5. Design changes, EIS clarifications and additional information

5.1 Design changes

NORTHERN SYDNEY FREIGHT CORRIDOR

EPPING TO THORNLEIGH

Sheet 5 of 9

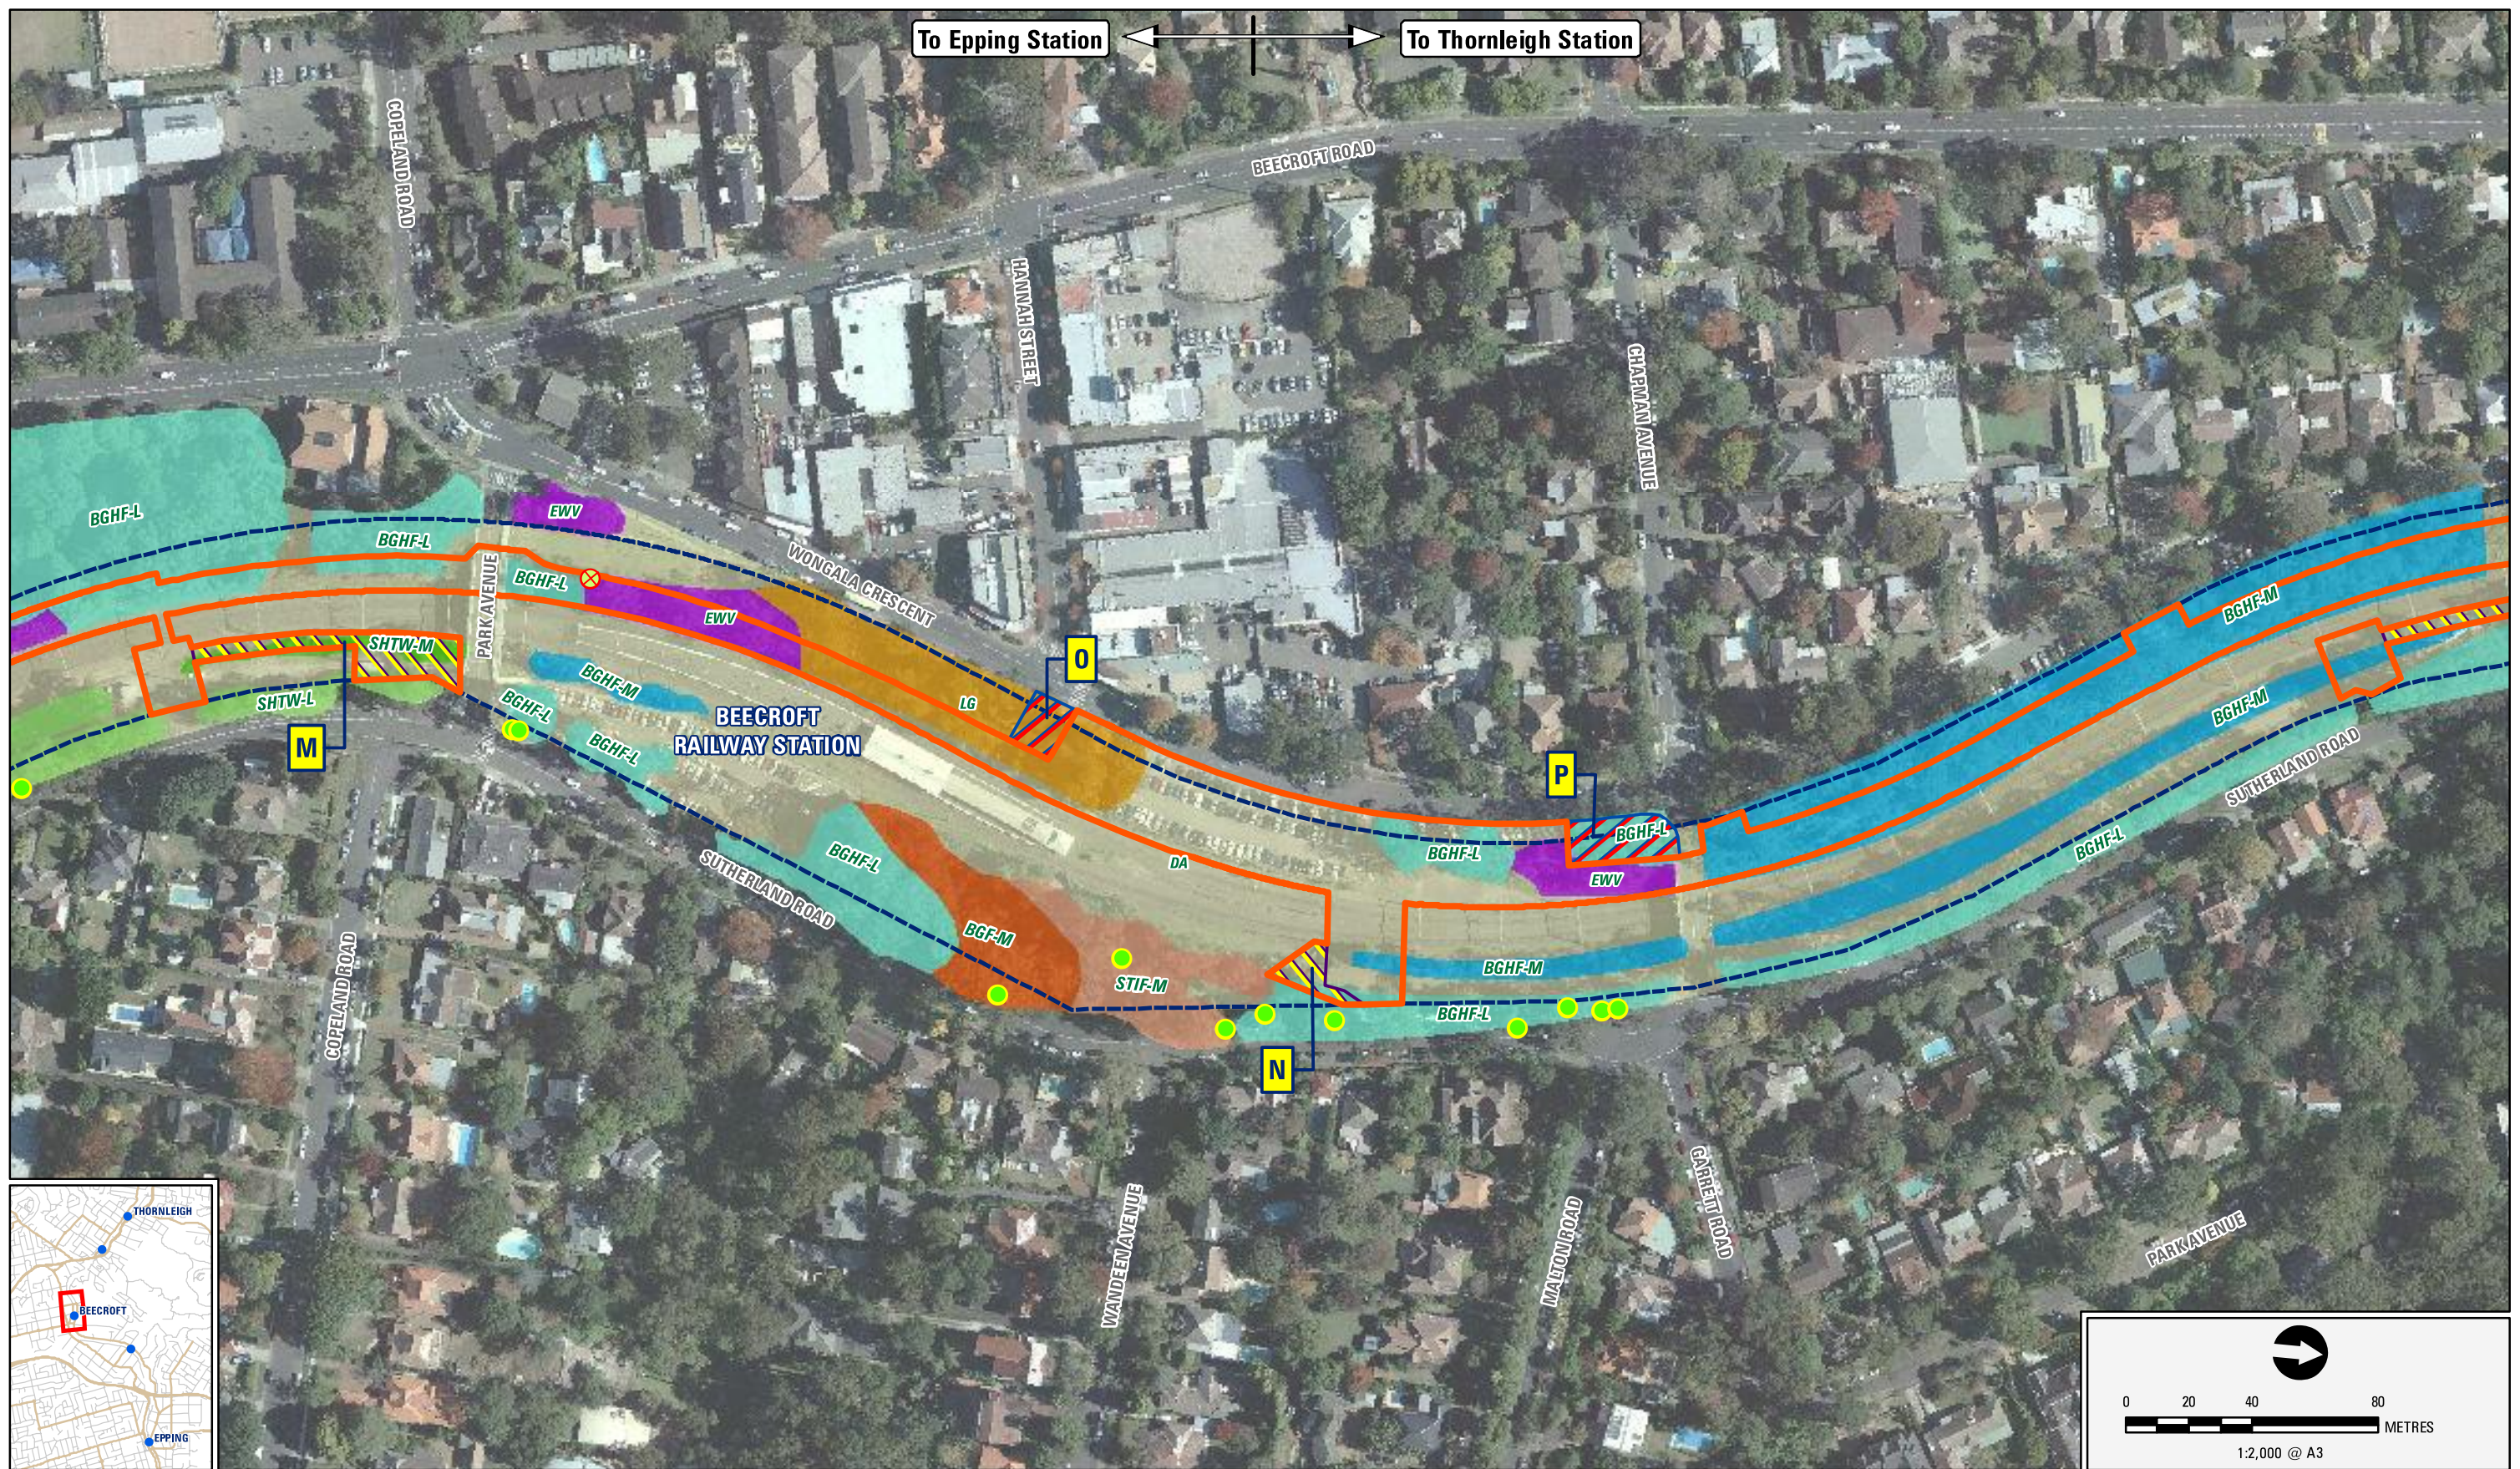
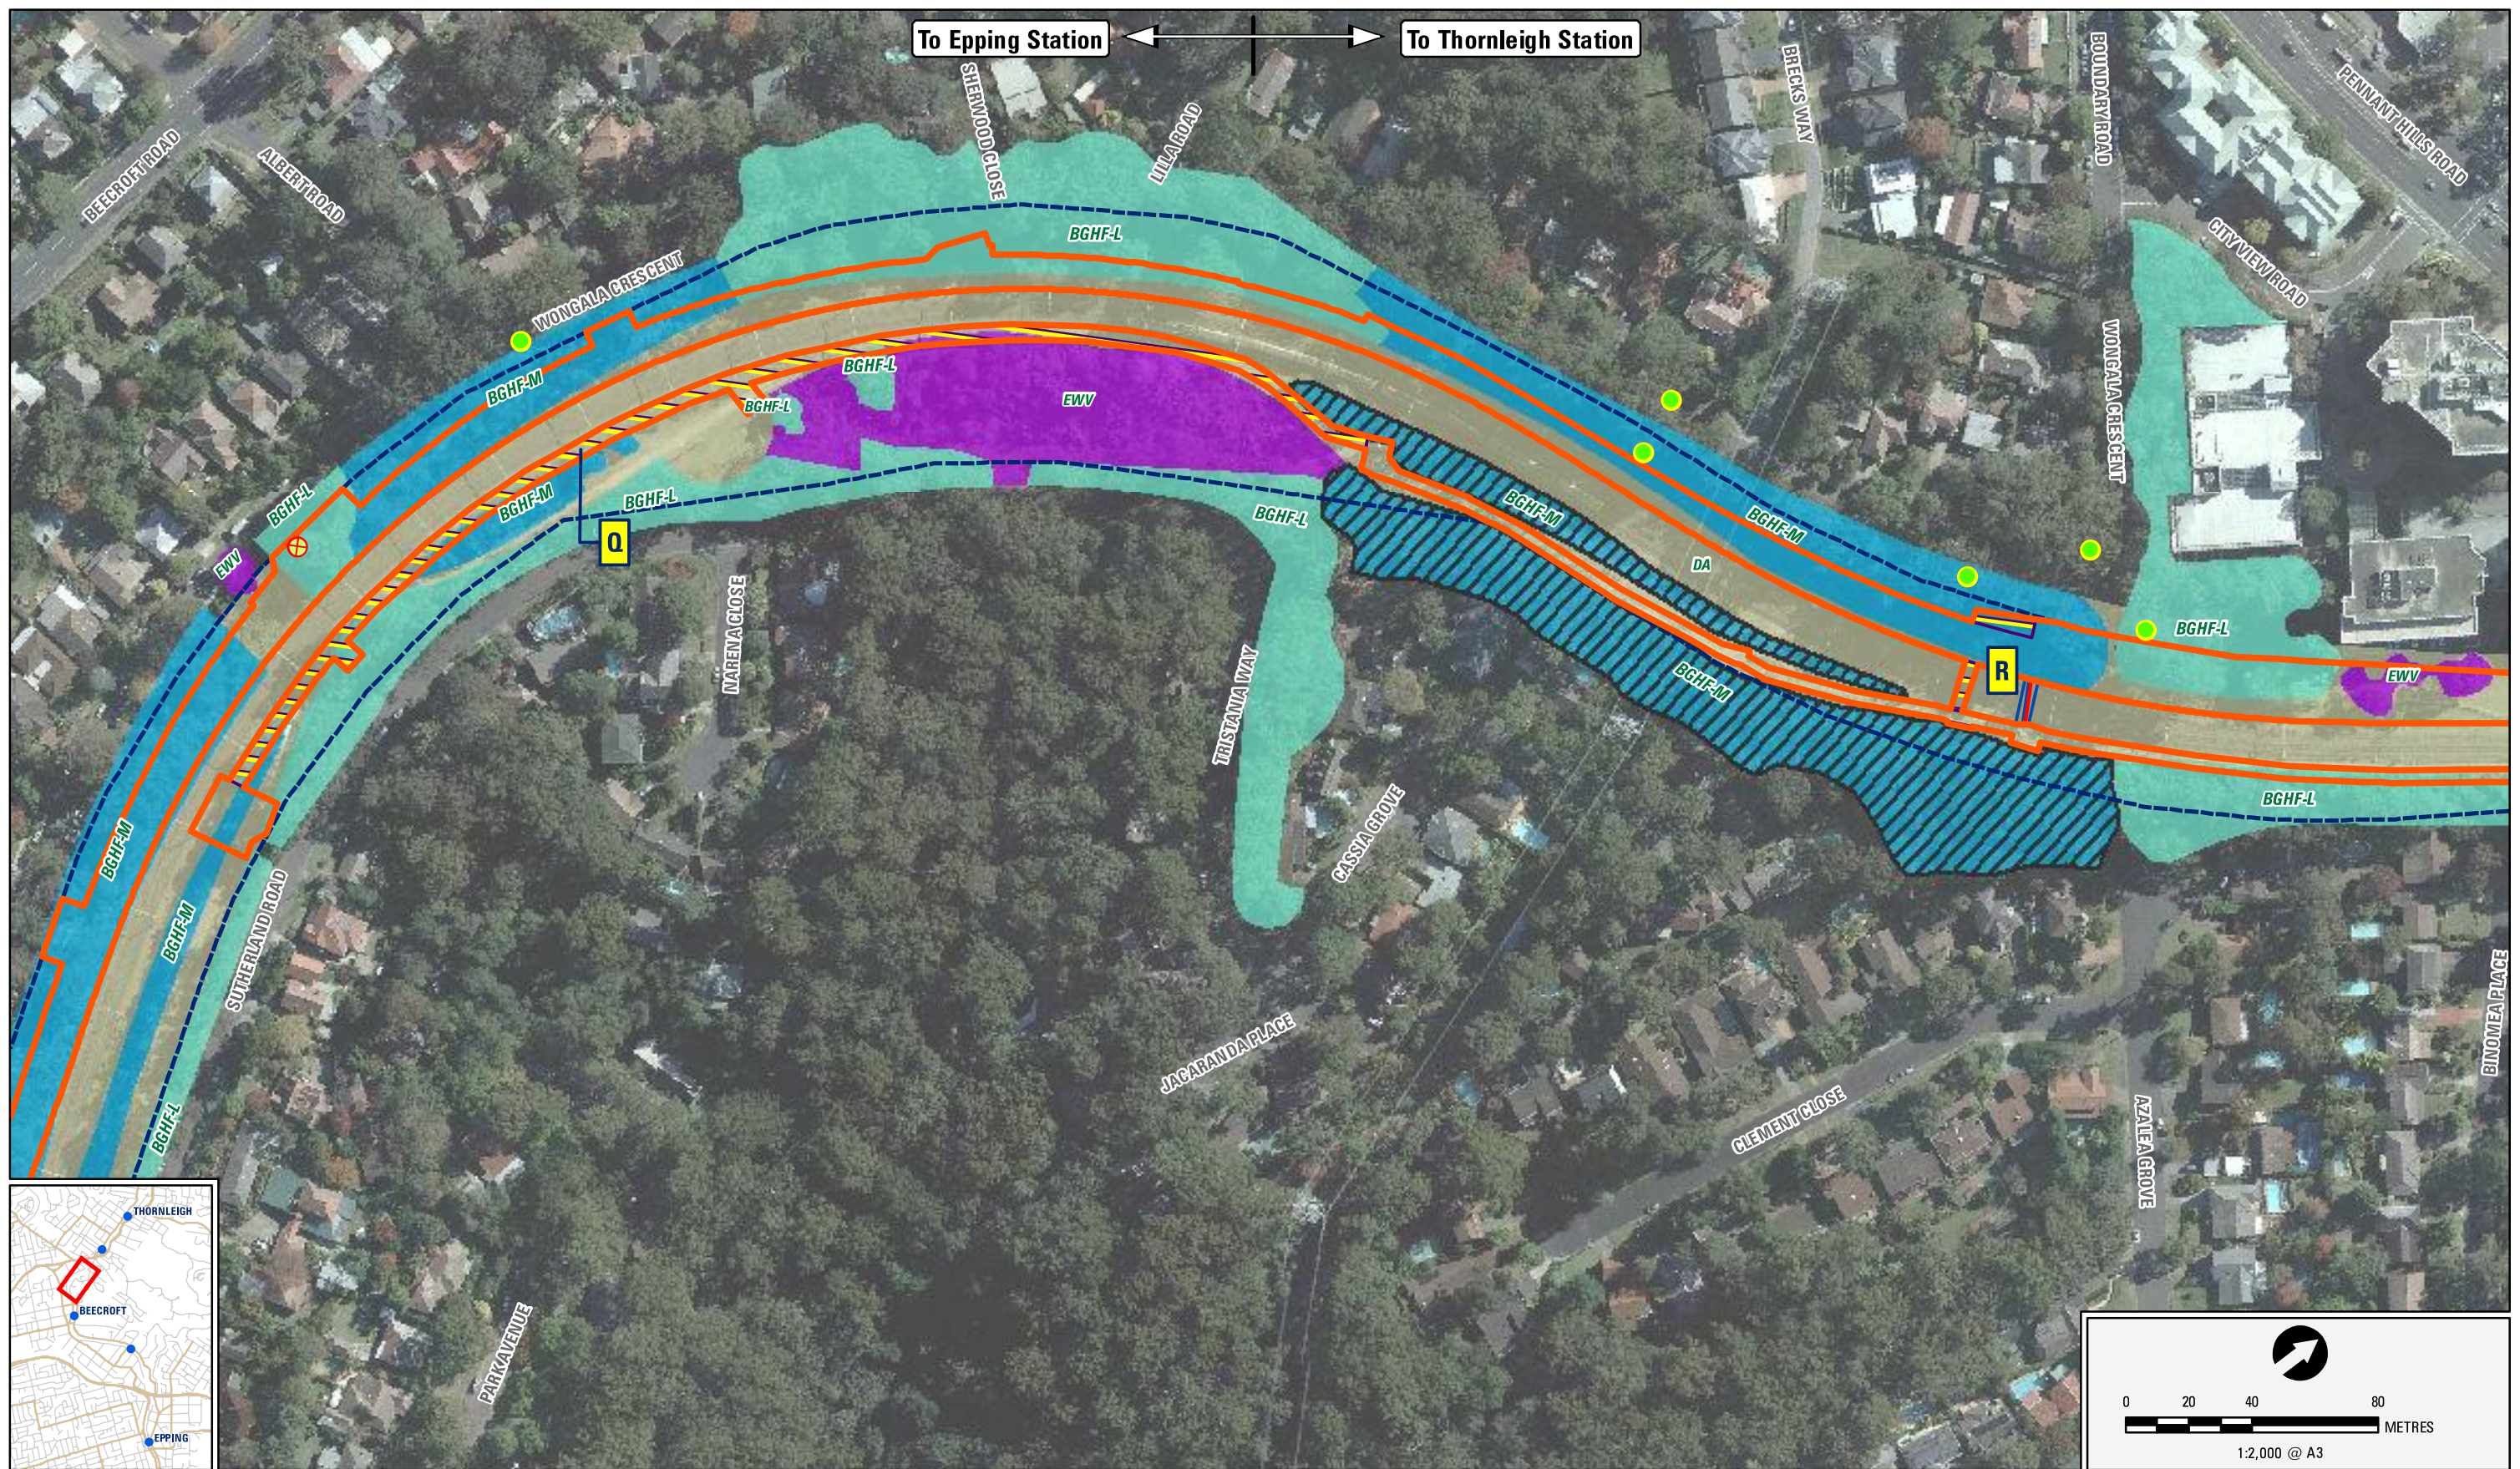
The construction impact area for the ETTT proposal, as shown in Figure 5.2 of the EIS, has been amended in various locations based on a review of constructability requirements. An outline of the proposed changes in construction impact area is provided in Table 5.1. A summary of the potential change in impact of the ETTT proposal as a result of each change is also provided in Table 5.1. The revised construction impact area for the ETTT proposal is shown in Figure 5.1.

Changed impact area	Description of proposed change	Summary of potential impacts
A	General work area increase to allow for the connection of the proposed railway services to existing facilities.	Increase in vegetation clearing and associated visual amenity impacts.
B1 and B2	Work area increased (onto Government owned land) to provide sufficient space for construction works, including the construction of the proposed viaduct and rail bridge crossing over the M2 Motorway and the delivery/storage of construction materials.	Increase in vegetation clearing and associated visual amenity impacts. Potential minor impact to heritage listed 'Bushland – Road reserve (between Carlingford Rd and Kandy Avenue)' (Hornsby LEP I 357) as a result of B1. Potential impact to the convict-built stone causeway crossing Devlins Creek (listed on Hornsby LEP) as a result of B2.
C1 and C2	General work area increase to provide additional area for access and construction of the proposed rail bridge crossing over the M2 Motorway.	Increase in vegetation clearing and associated visual amenity impacts. Potential impact to the convict-built stone causeway crossing Devlins Creek (listed on Hornsby LEP) as a result of C1.

D	Increase in trenching or installation of galvanised steel troughing for the connection of railway services between areas north and south of the M2 Motorway.	Increase in vegetation clearing and associated visual amenity impacts.

Changed impact area	Description of proposed change	Summary of potential impacts
E	Widened impact area to facilitate the establishment of a general work area. Area required for additional laydown, materials storage, construction of cuttings, establishment of a haul road for the removal of spoil, as well as to provide access for launching the structure of the proposed rail bridge crossing over the M2 Motorway.	Increase in vegetation clearing and associated visual amenity impacts. Area located adjacent to 'Ashby', a heritage listed house at 94 The Crescent, Cheltenham (Hornsby LEP I 297). Potential reduction in screening vegetation along the road reserve.
F	Modification to the combined services route (CSR).	Increase in vegetation clearing.
G1 and G2	General works area increase for a new power room, radio antenna and equipment room, and backup power supply.	Increase in vegetation clearing and associated visual amenity impacts.

H	Impact area widened to property boundary.	Nil.
I	General works area increase to facilitate construction of a new railway services pit and connection with public utilities/services.	Increase in vegetation clearing and associated visual amenity impacts.
J	Reduction in impact area due to the review of constructability requirements.	Reduction in vegetation clearing and associated visual amenity impacts.
K	Reduction in impact area due to the reduced clearance required at construction access gates.	Reduction in vegetation clearing and associated visual amenity impacts.
L	Reduction in impact area due to the reduced clearance required at construction access gates.	Reduction in vegetation clearing and associated visual amenity impacts.
M	General works area increase to facilitate construction of a new railway services pit and connection with public utilities/services.	Increase in vegetation clearing and associated visual amenity impacts.

O	Reduced area to reduce impacts on Beecroft Station Gardens and playground.	Reduction in vegetation clearing and associated visual amenity impacts.
P	Optimised car parking area to reduce impact area without reducing the number of car parking spaces to be provided.	Reduction in vegetation clearing and associated visual amenity impacts.
N	General works area increase to facilitate construction of a new railway services pit and connection with utilities.	Increase in vegetation clearing and associated visual amenity impacts.
Q	Increased construction impact area for the establishment of the combined services route and pits. Increase in trenching for services to facilitate construction of new pits and connections to railway services.	Increase in vegetation clearing and associated visual amenity impacts. However, impacts would be mostly confined to existing access roads within the rail corridor.
R	Increase in construction impact area due to a refinement of the new high voltage cable route	Increase in vegetation clearing and associated visual amenity impacts.

S	General works area increase to facilitate construction of additional services as well as facilitating construction access from Hampden Road, if required.	Increase in vegetation clearing and associated visual amenity impacts. However, impacts would be mostly confined to existing access roads within the rail corridor.
T	General works area increase for the installation of additional railway services.	Increase in vegetation clearing and visual amenity impacts
U, V and W	Reduction in impact area due to the reduced clearance required at construction access gates.	Reduction in vegetation clearing and associated visual amenity impacts.
